WHITE ESTATES SUBDIVISION

APPLICATION NUMBER 3 DATE September 17, 2009

REQUEST Subdivision

WHITE ESTATES SUBDIVISION

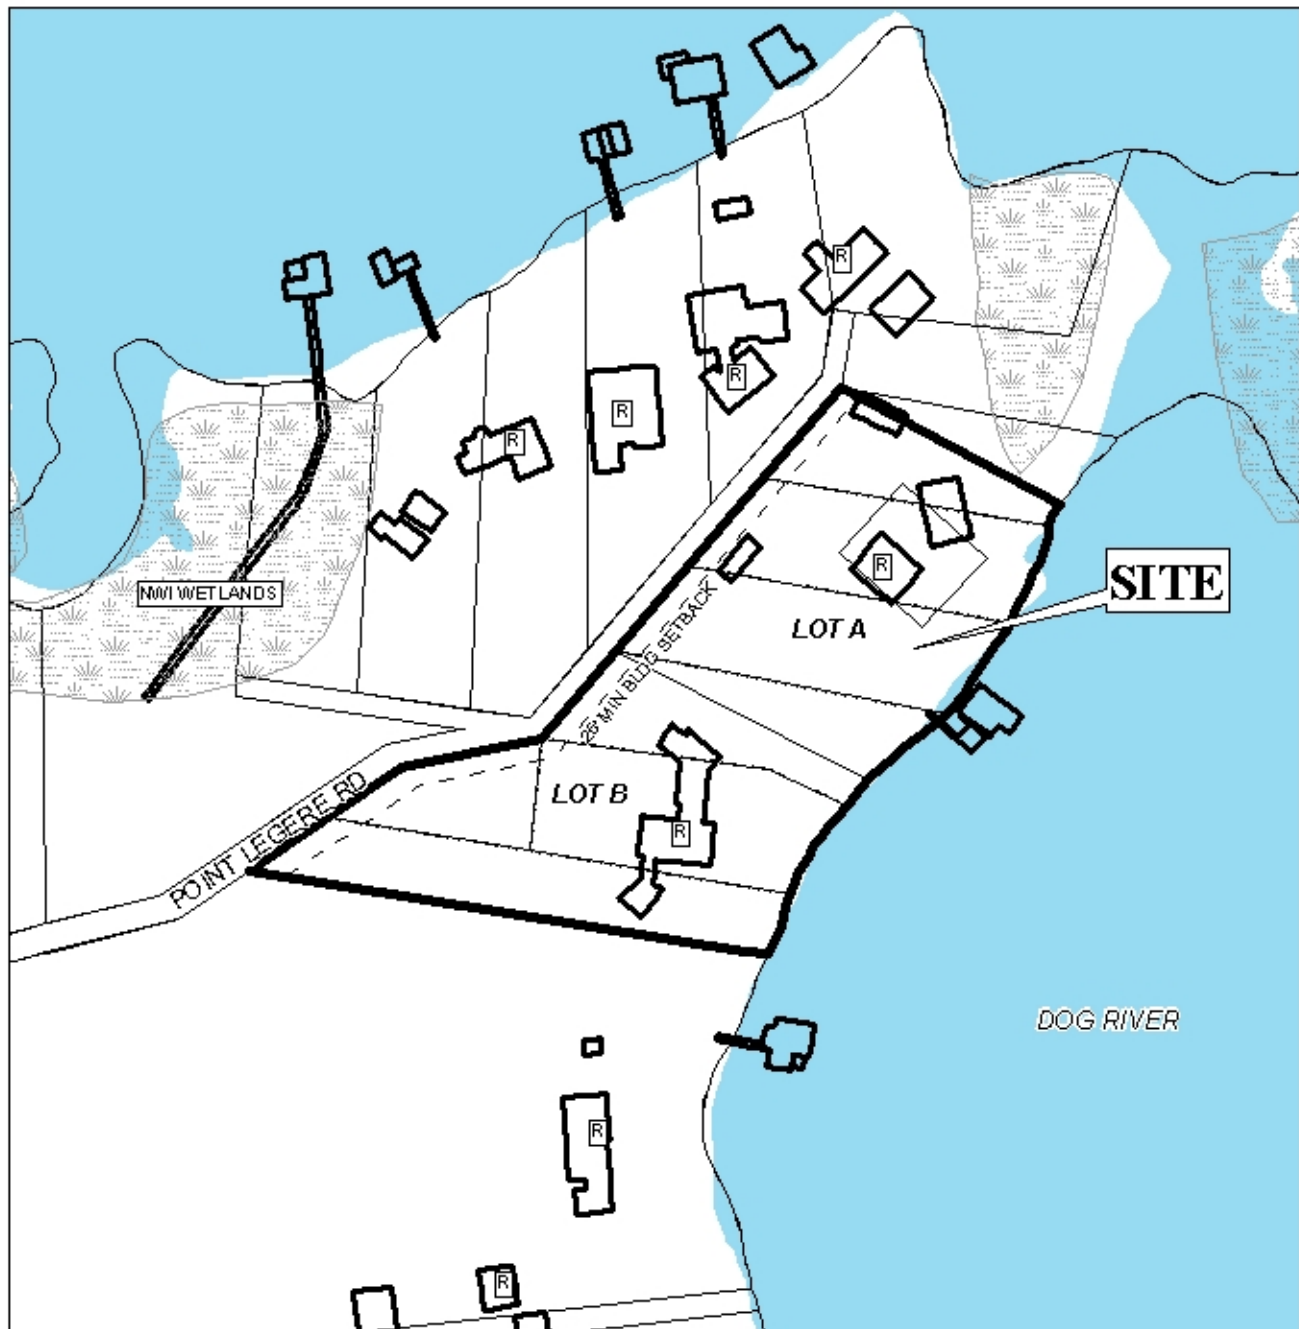
The proposed subdivision fronts Point Legere Road with a substandard 20' right-of-way; therefore, dedication would be required to provide 25' from the centerline. The preliminary plat indicates frontage dedication as generally measured from the centerline; however, in areas the dedication parallels the curved paved road surface and not the true angular centerline of the

right-of-way. Therefore, the plat should be revised to indicate any required frontage dedication as measured from the true angular right-of-way centerline and not the curved paved road surface. The plat should also be revised to indicate the 25' building setback line as measured from the angular dedicated right-of-way. As a means of access management, a note should be required on the final plat stating that each lot is limited to two curb cuts, with the size, location, and design to be approved by Traffic Engineering and conform to AASHTO standards. Each lot should be labeled on the final plat with its size in acres and square feet, or a table should be furnished on the final plat providing the same information.

As illustrated on the Environmental GIS database, a portion of the Northern part of the site may contain NWI wetlands. If wetlands are present, the area may be environmentally sensitive; therefore, if approved, the approval of all applicable federal, state and local agencies would be required prior to the issuance of any permits or land disturbance activities.

This application was heldover from the August 20th meeting at the applicant's request. A revised plat has been submitted correcting the North line of Lot 8, Point Legere Subdivision, and indicating that all of that lot is actually within the boundary of this subdivision. This clears the matter of only a portion of that lot having been included in the original plat submitted for review and negates the requirement of the inclusion of the neighboring property to the North in this subdivision.

- 1) *dedication of sufficient right-of-way along Point Legere Road to provide 25' from the centerline;*
- 2) *illustration of the 25' minimum building setback line as measured from any required dedication;*

- 3) *placement of a note on the final plat stating that each lot is limited to two curb cuts, with the size, location, and design to be approved by Traffic Engineering and conform to AASHTO standards;*

- 4) *labeling of each lot with its size in acres and square feet, or the furnishing of a table on the final plat providing the same information;*
- 5) *placement of a note on the final plat stating that development of this site must be undertaken in compliance with all local, state, and Federal regulations regarding endangered, threatened or otherwise protected species;*

- 6) *placement of a note on the final plat stating that if NWI wetlands are present on the site, the approval of all applicable federal, state and local agencies would be required prior to the issuance of any permits or land disturbance activities; and*

- 7) *subject to the Engineering Comments: (Show Minimum FFE on each lot shown on plat. Fill is not allowed without City of Mobile Engineering Department approval, which at a minimum requires providing compensation or completing a flood study. Wetland locations must be shown on plat. Any work in wetlands must be permitted through the Corps of Engineers and copies of permits must be provided the City prior to obtaining Land Disturbance Permits. Show the lot line adjacent to the water. Must comply with all storm water and flood control ordinances. Any work performed in the right of way will require a right of way permit).*
